Subject: AP1000 COL Standard Technical Report Submittal of APP-GW-GLN-131 (TR 131),
Revision 1

Title: Miscellaneous AP1000 Design Changes

Technical Report 131 addresses a few miscellaneous design changes made to AP1000 that are incorporated into Revision 16 of the Design Control Document.

Figure 2.3.11-1
Gaseous Radwaste System

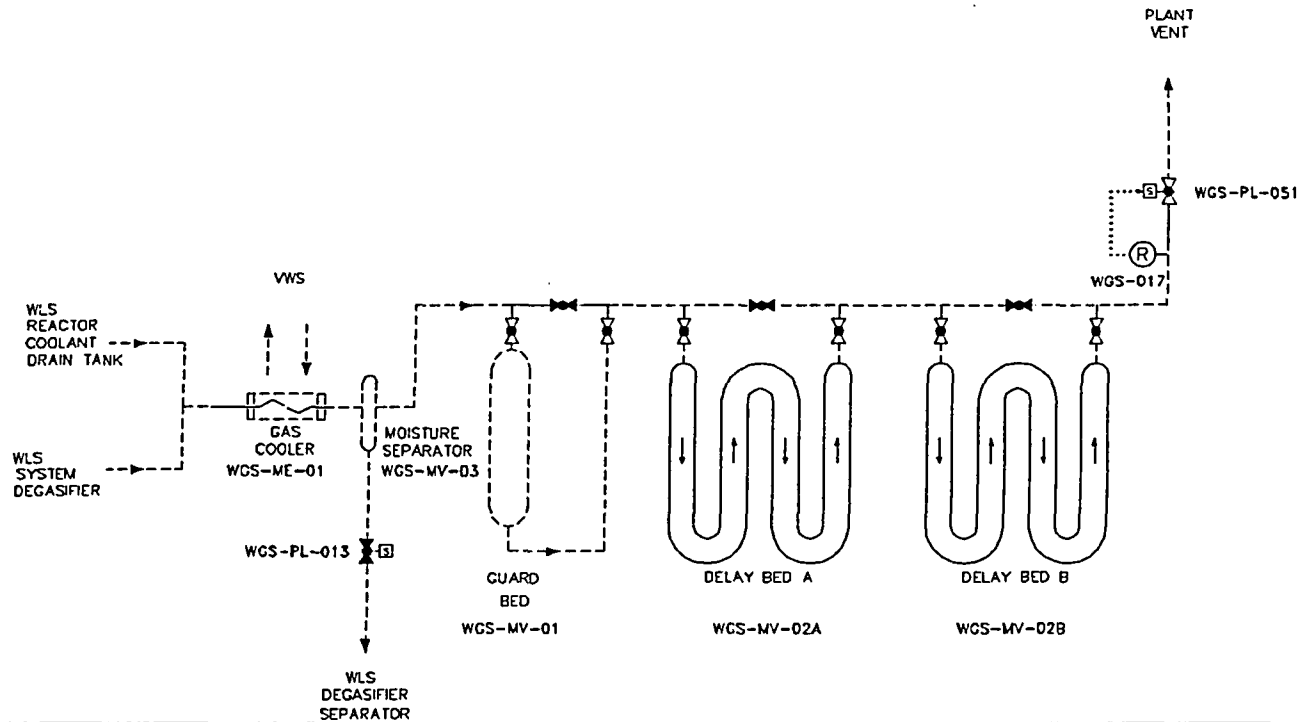
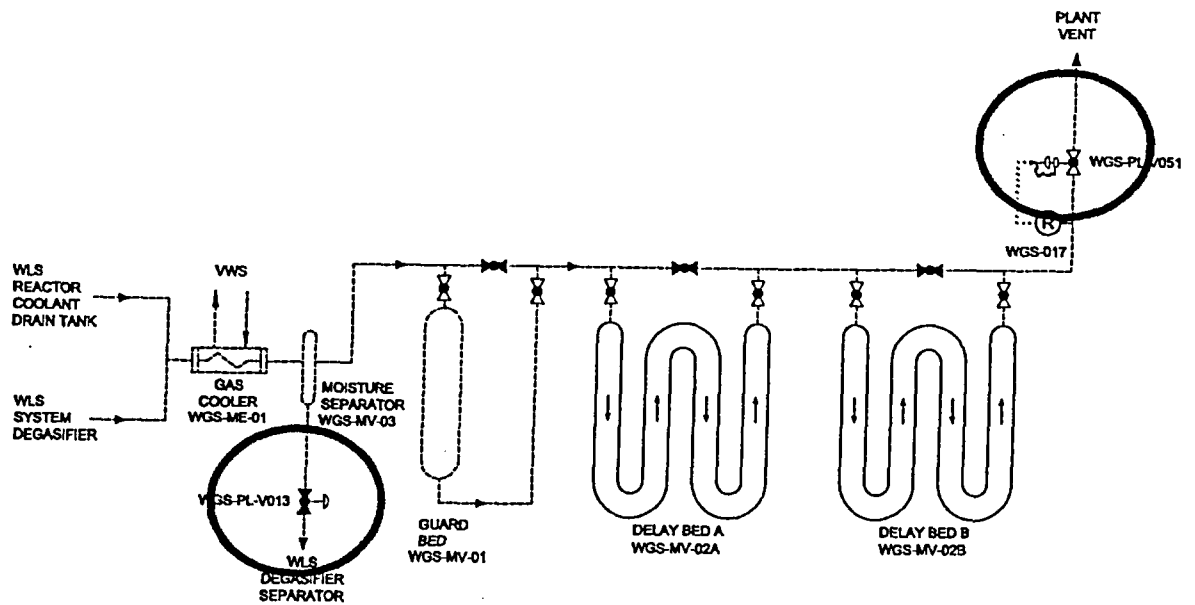
The current version of the Gaseous Radwaste System (WGS) simplified sketch shown in the DCD does not accurately depict the current status of the WGS design. The sketch will be updated to reflect the current AP1000 WGS design by correcting the valve type for the discharge valve and the moisture separator drain valve.

Figure 9.5.1-1 (Sheet 1 of 3)
 Fire Protection System
 Piping and Instrumentation Diagram
 (REF FPS 001)

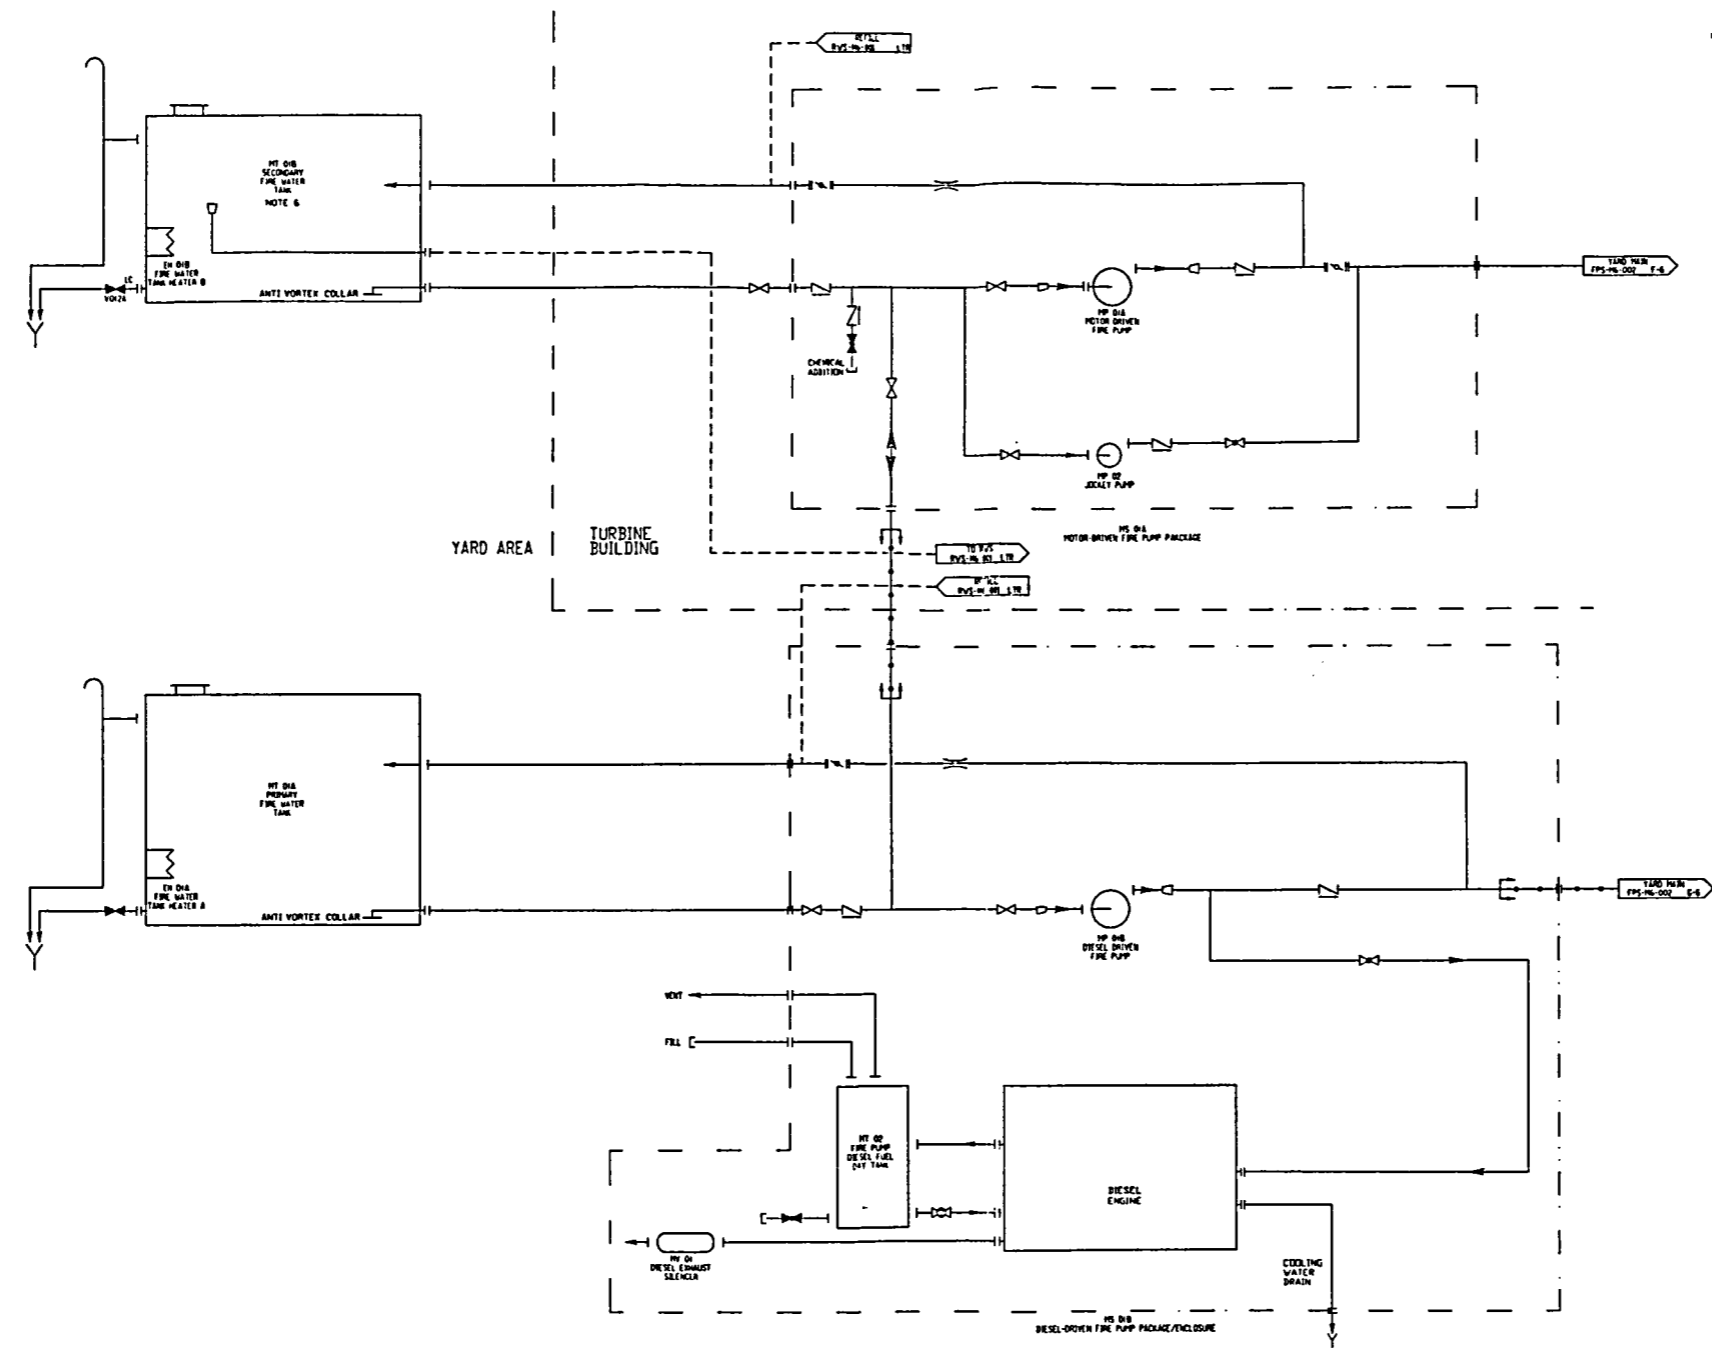
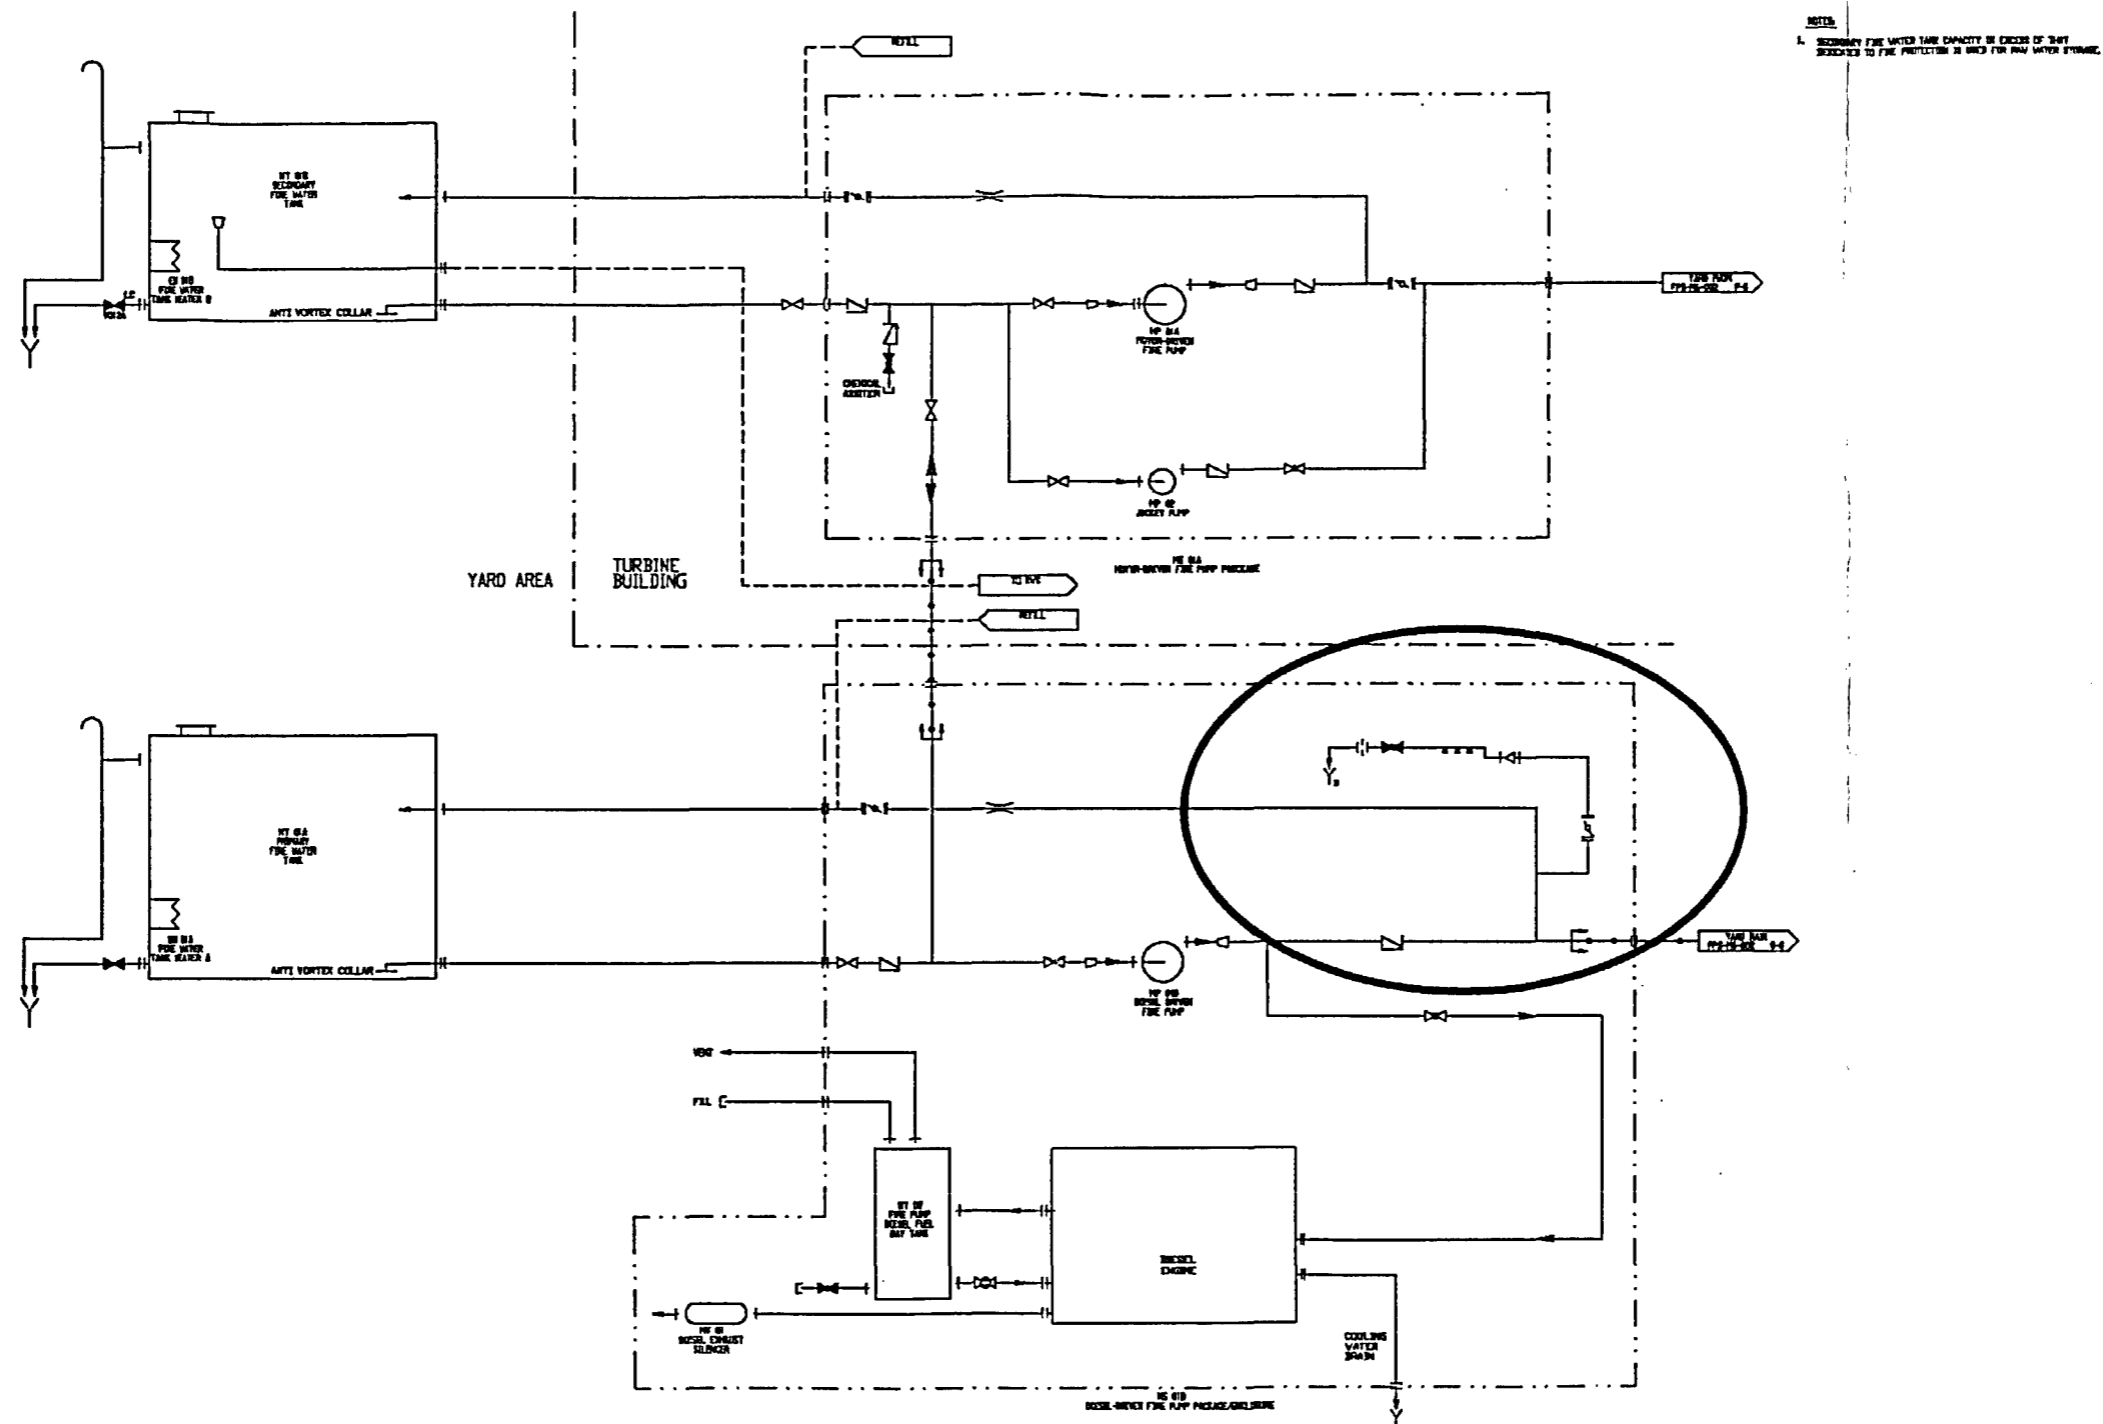
Change 6: Addition of sprinklers that exist in the diesel driven fire pump enclosure

The current design has sprinklers in the diesel driven fire pump package. The figure included in this TR shows these sprinklers.
